2026 Summary of Revisions

City of Bismarck Construction Specifications for Municipal Public Works Improvements

The City of Bismarck has revised the Construction Specifications for Municipal Public Works Improvements for 2026.

**PAD MOUNTED FEED POINT DETAIL
(SHEET 1 OF 2)**

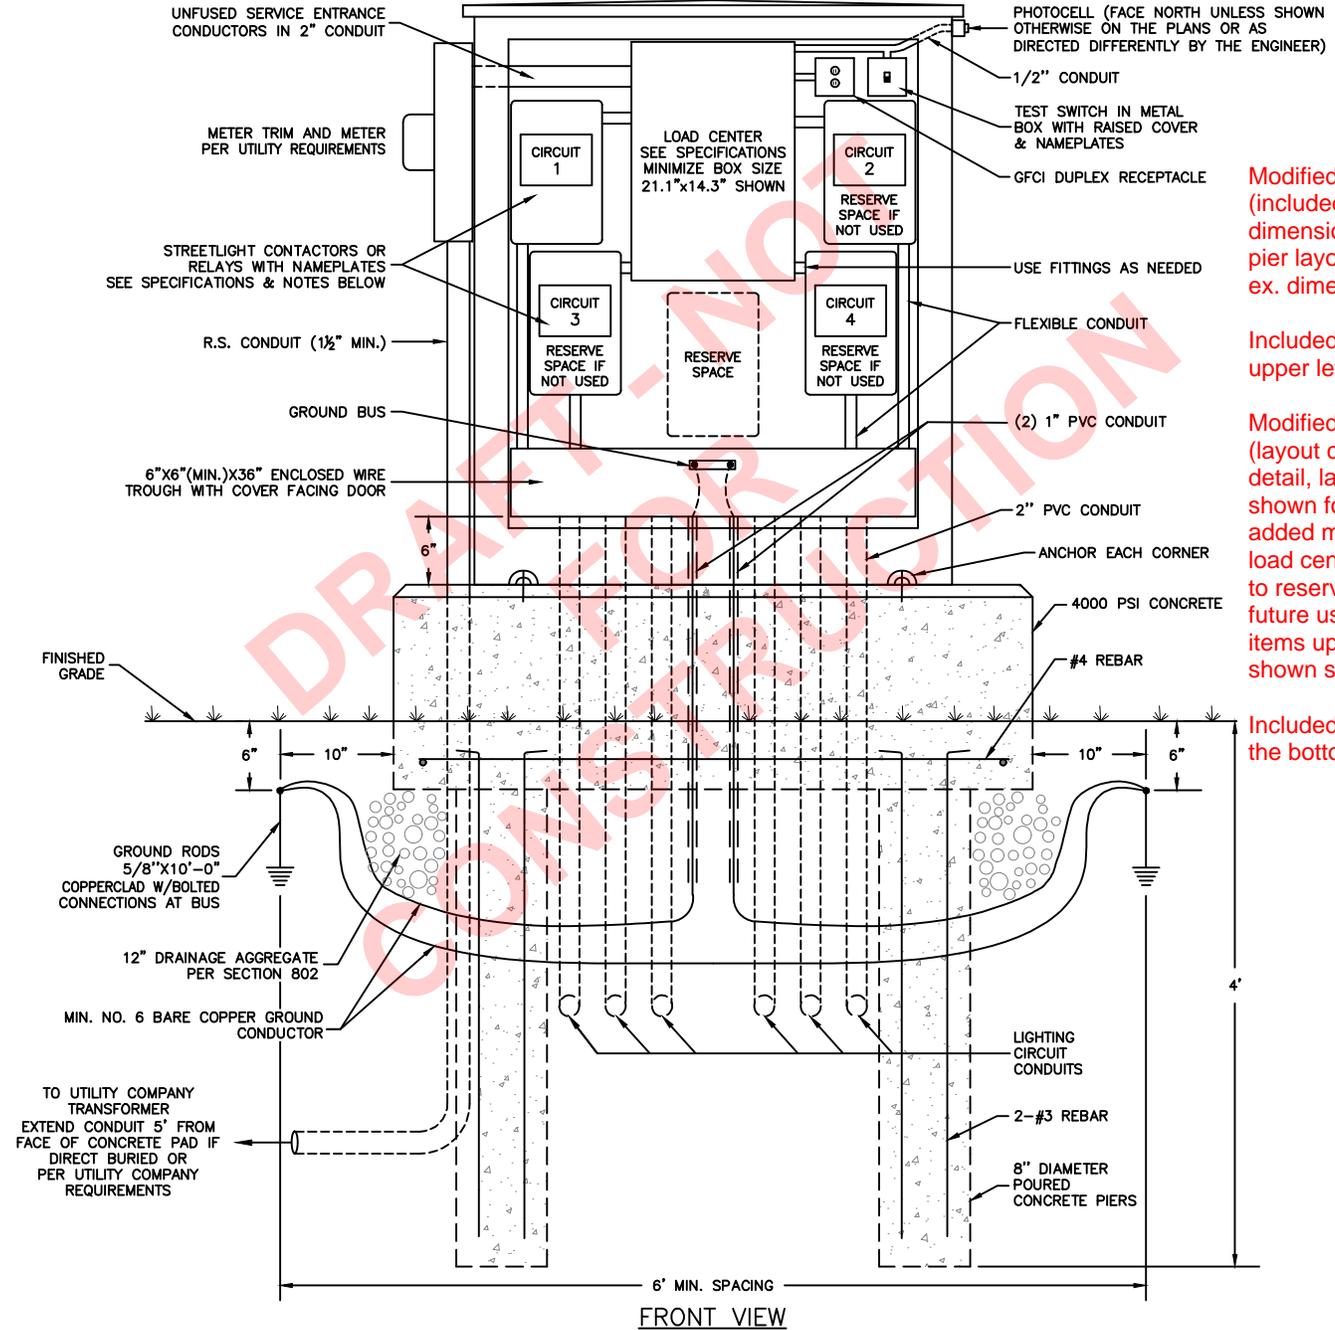
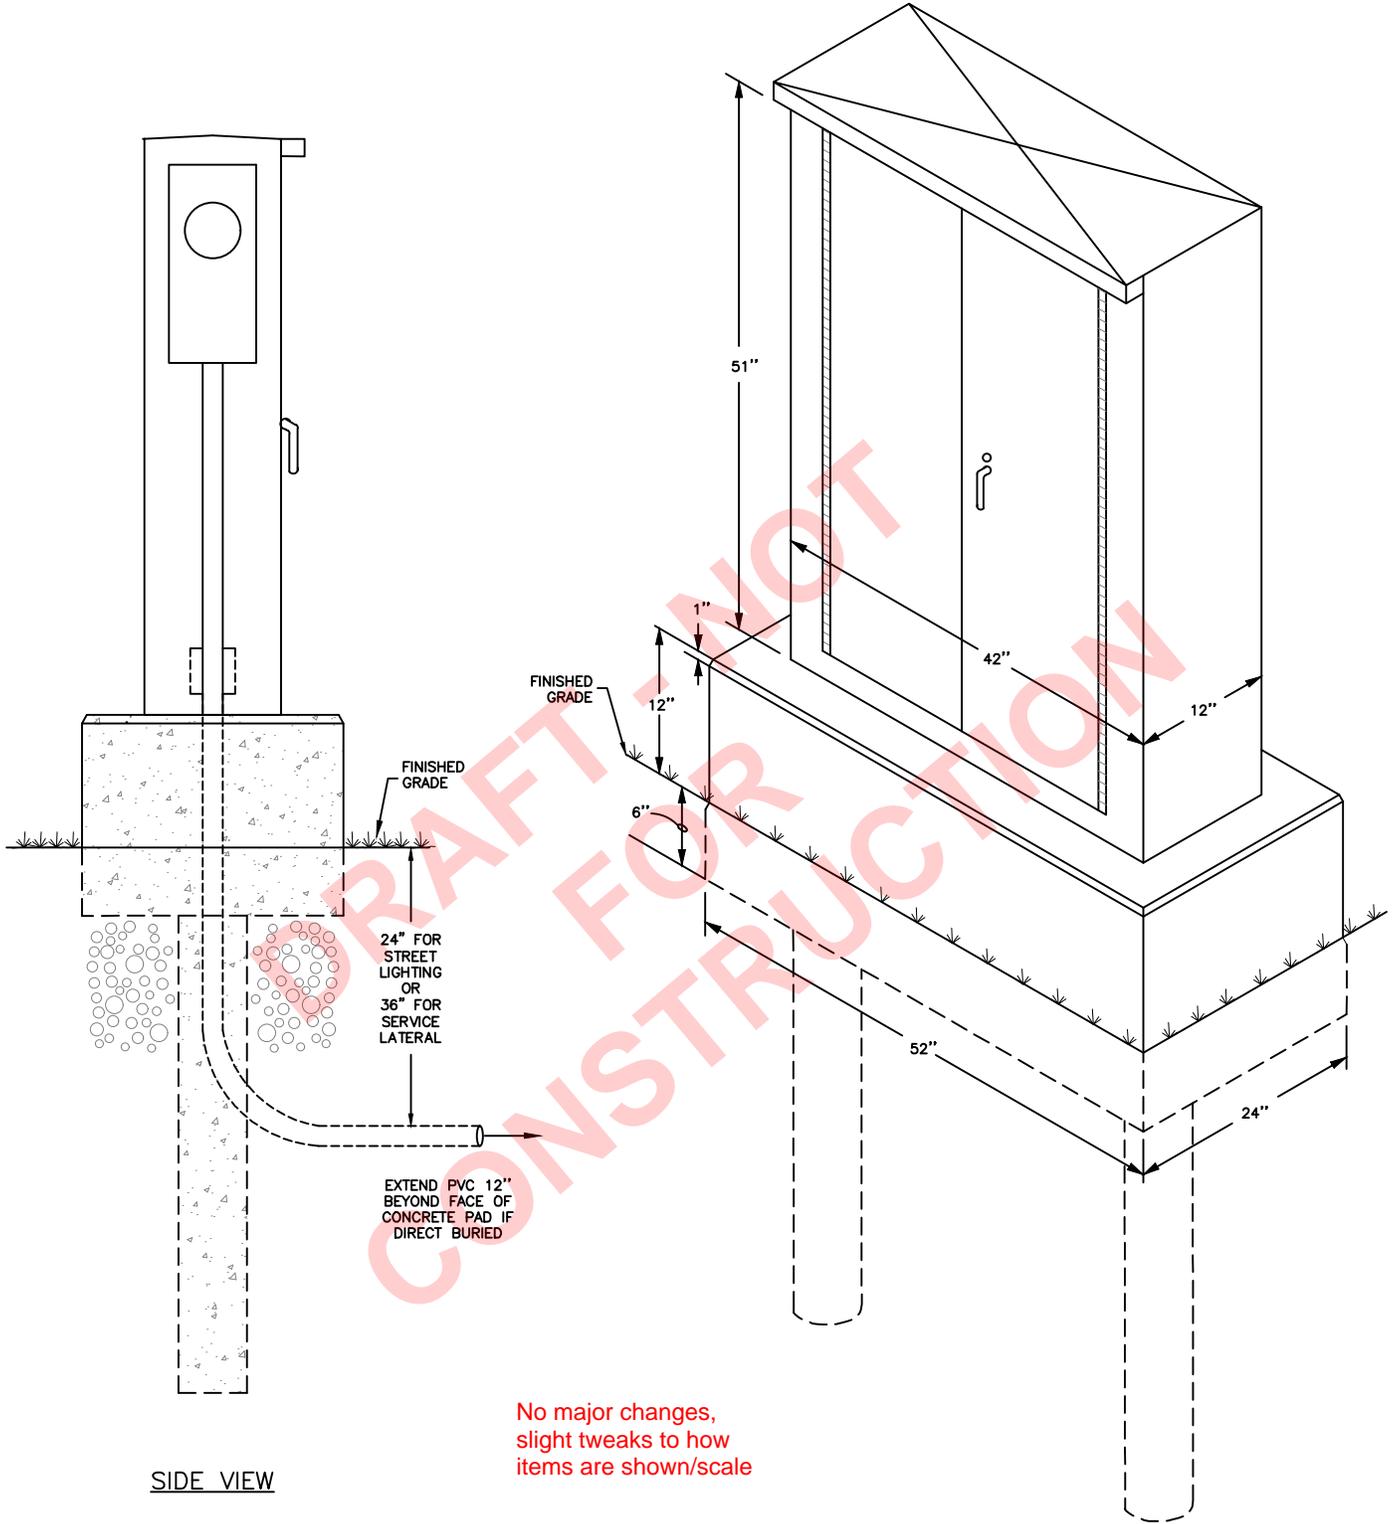
Modified top view (included new dimension and change pier layout, modified ex. dimension)

Modified Front view (layout changes, more detail, larger scale shown for some items, added min. box size for load center, added note to reserve space for future use underground items updated and shown slightly different)

Included notes 1-3 at the bottom

**PAD MOUNTED FEED POINT DETAIL
(SHEET 2 OF 2)**

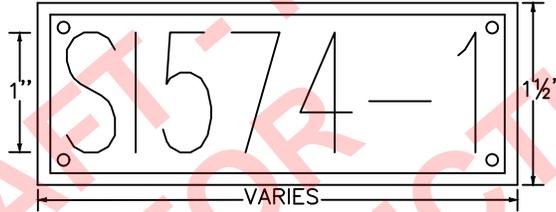
Updated to show "SI" in front of first example for 574-1

STANDARD
DETAIL NO.
1003-5

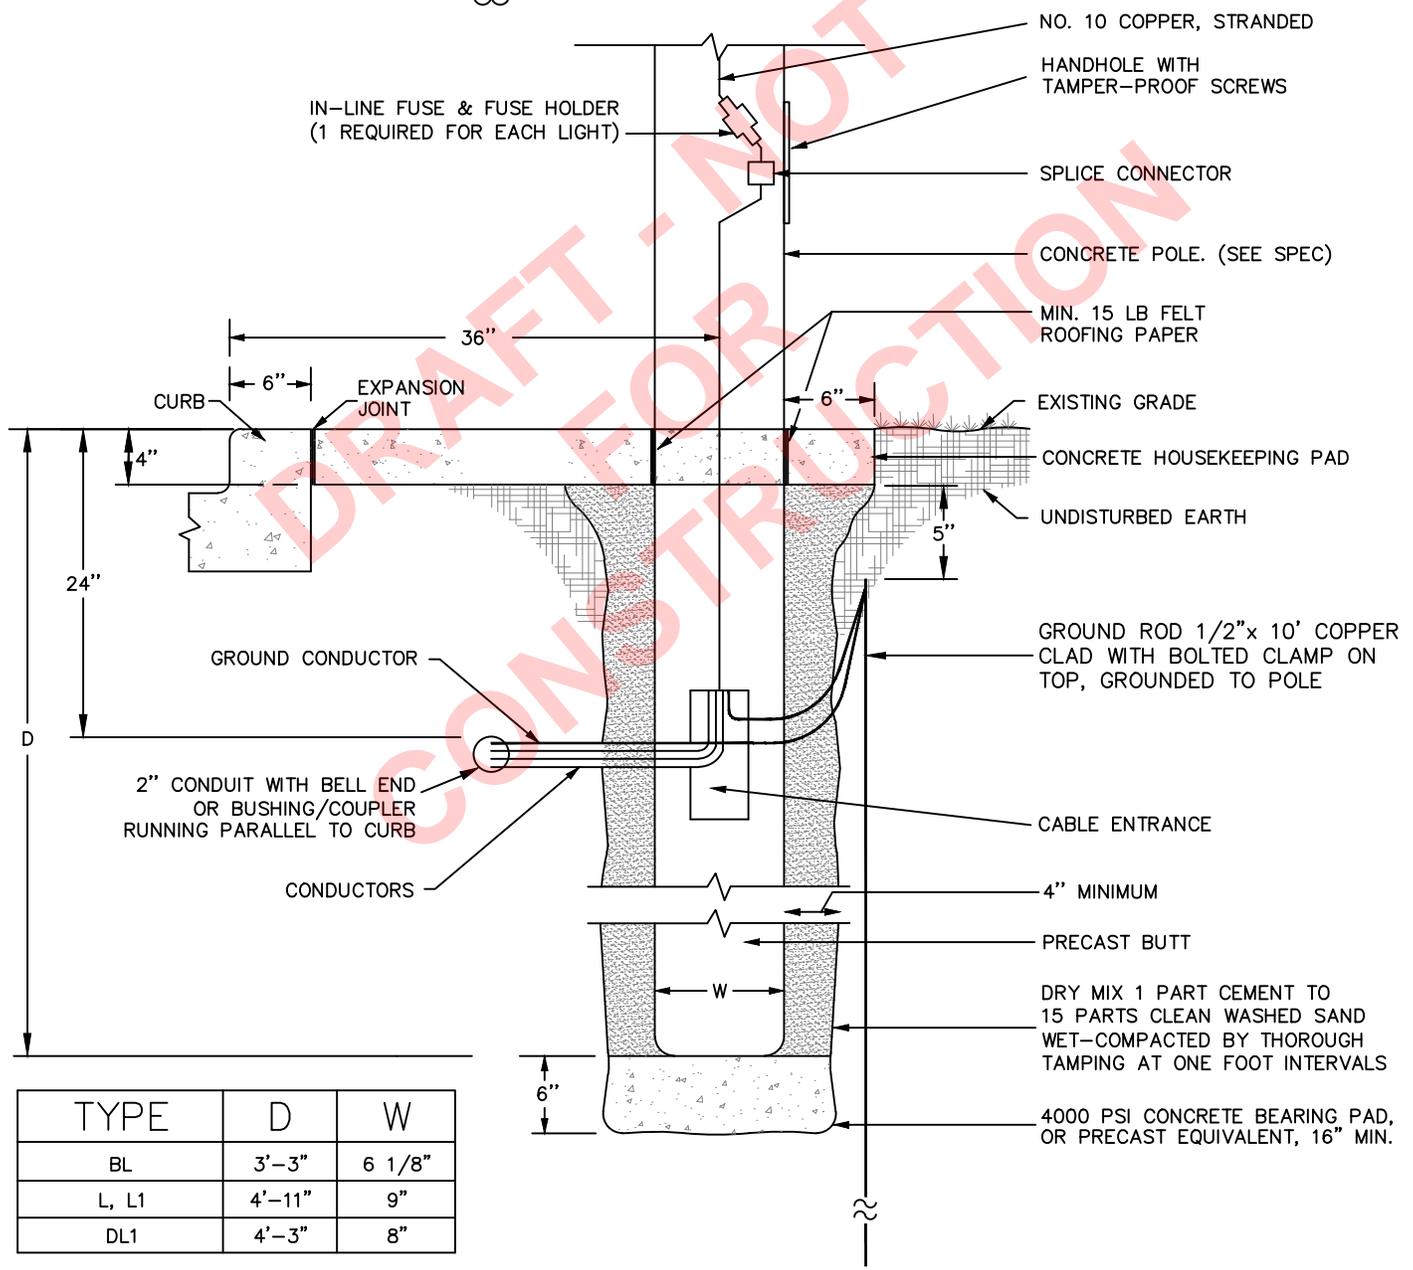
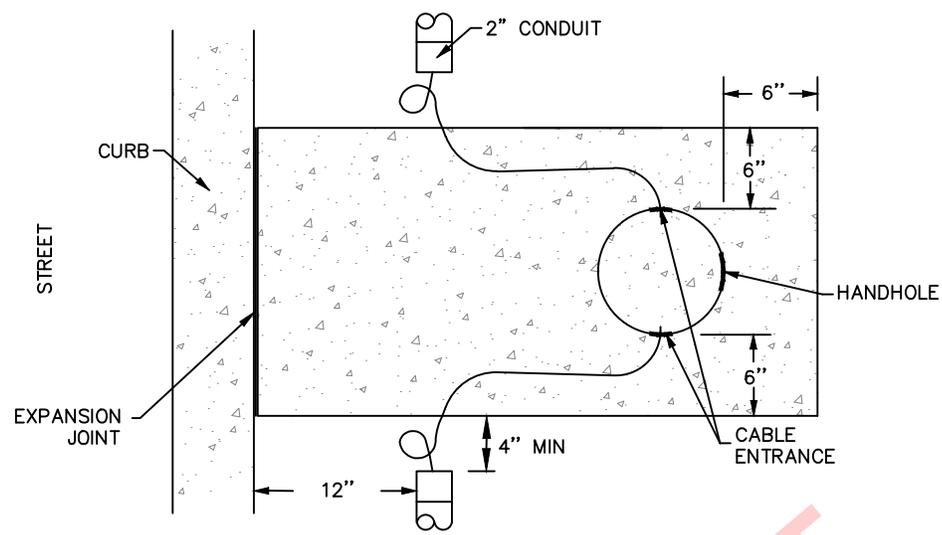
Updated both views to show more accurately and closer to scale

EMBEDDED BASE DETAIL

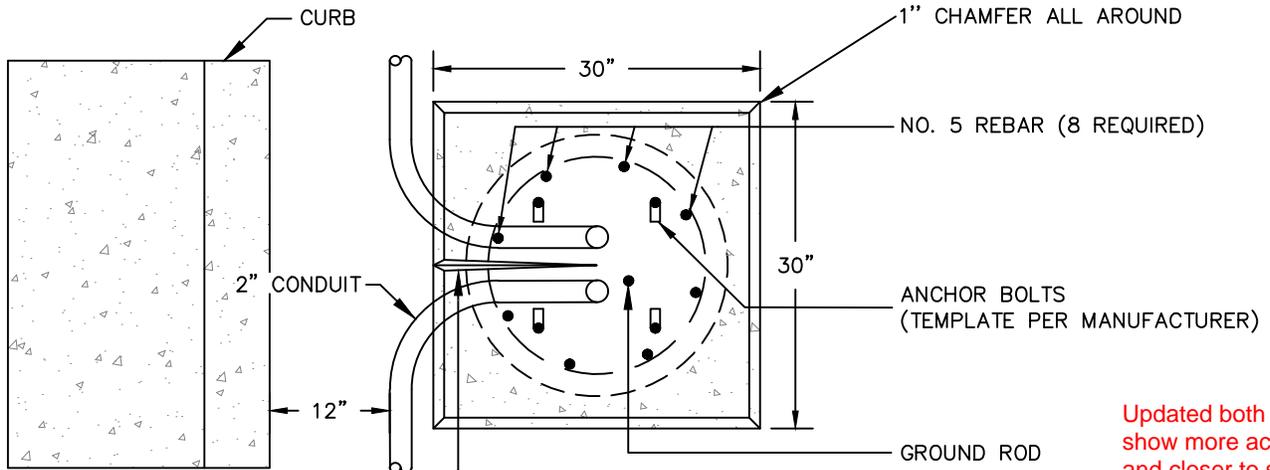
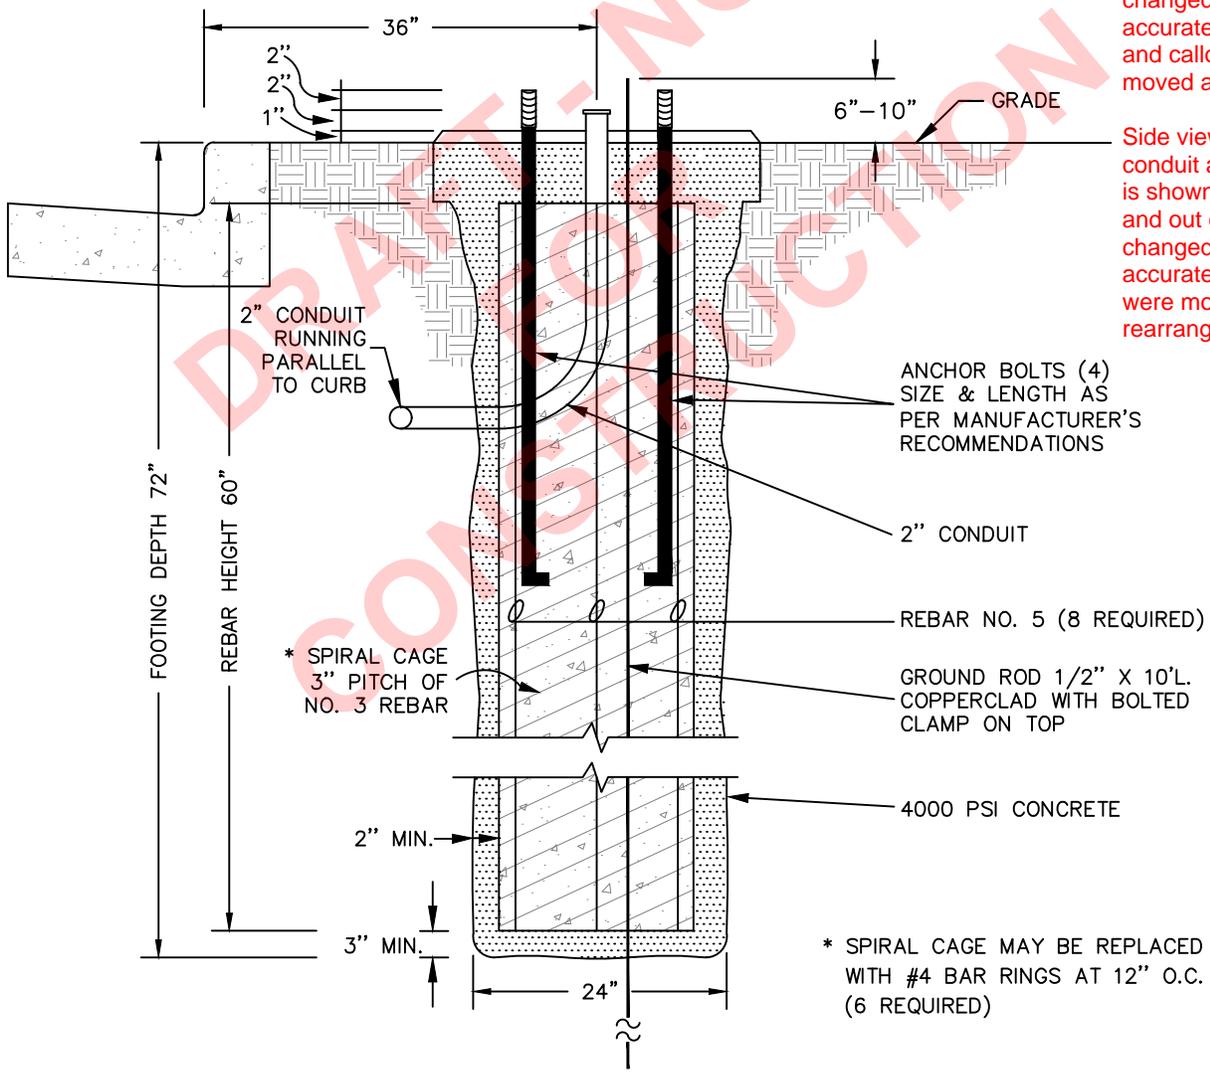
Updated both views to show more accurately and closer to scale

Top view: the way the conduit and conductor is shown coming into and out of the pole was changed to be more accurate, dimensions and callouts were moved and rearranged

Side view: the way the conduit and conductor is shown coming into and out of the pole was changed to be more accurate, and callouts were moved and rearranged

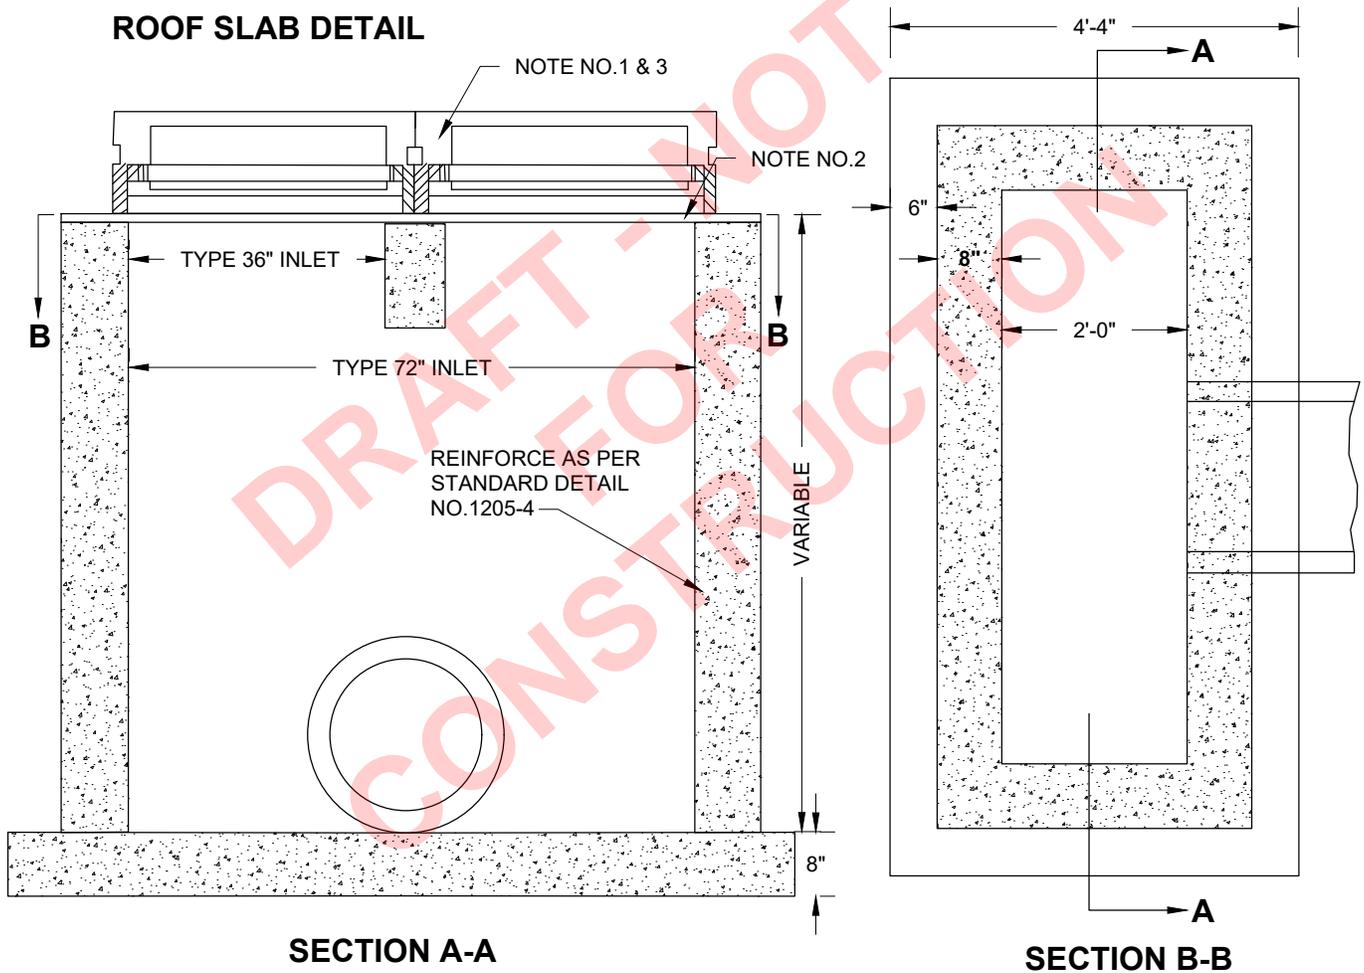
**REMOVED ROOF SLAD
DETAIL AND NOTES,
ROOF SLAB NOT USED**

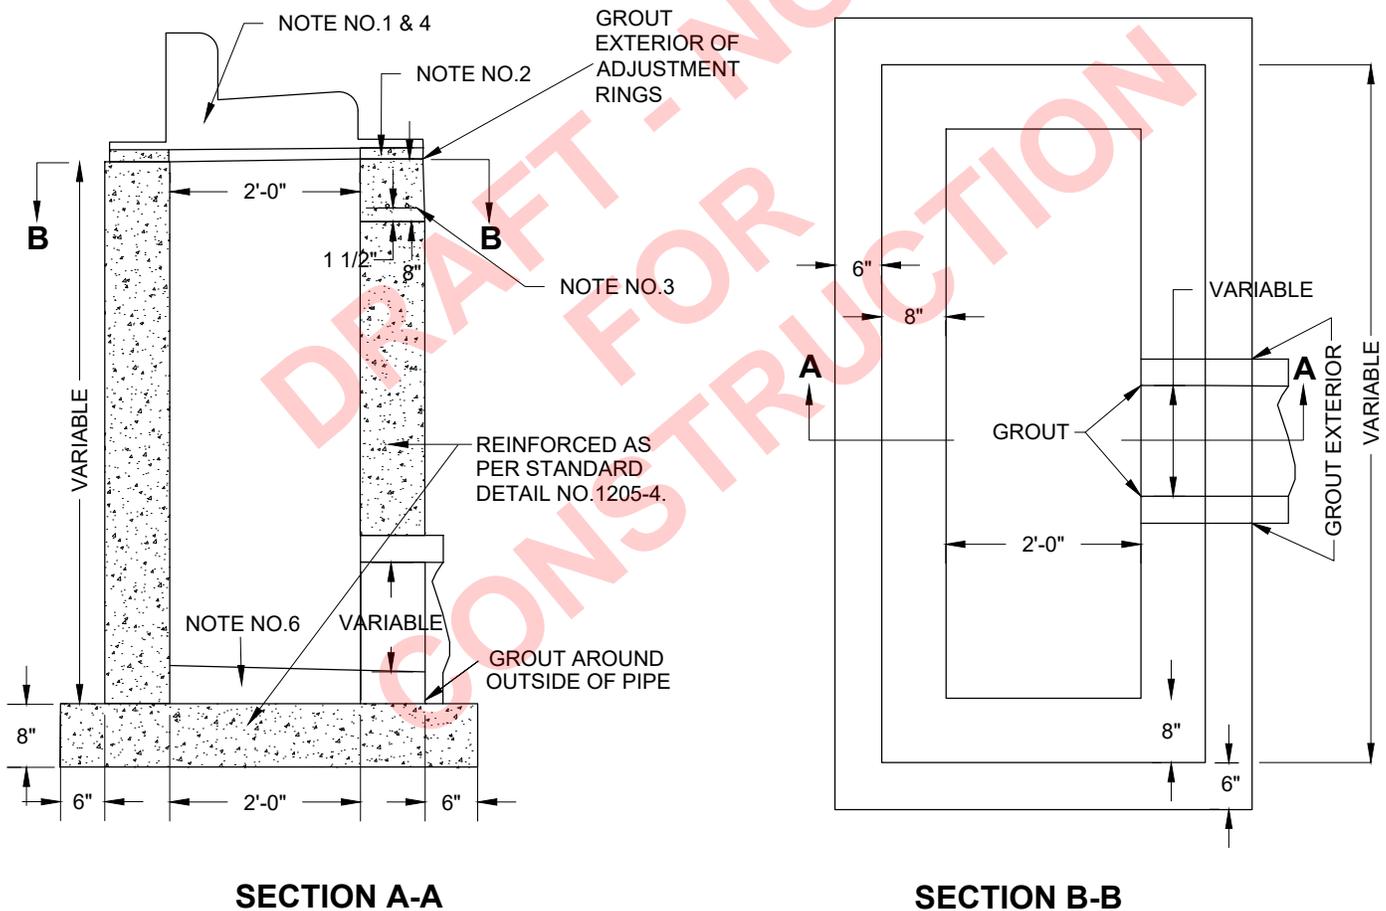
**REVISED TO CLARIFY
 STRUCTURE BUILDS**

MANHOLE CASTING STANDARD ADJUSTMENT

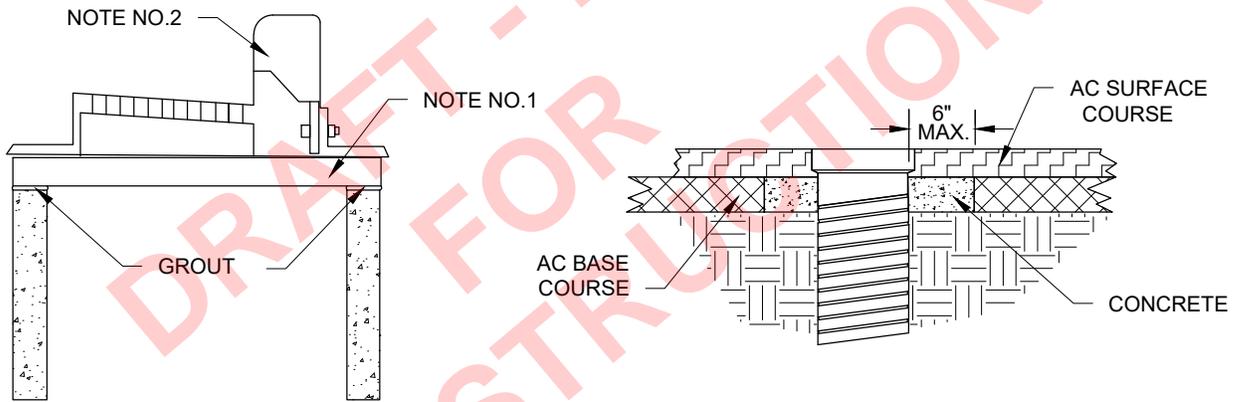
REMOVED I/I BARRIER
AND CLARIFY
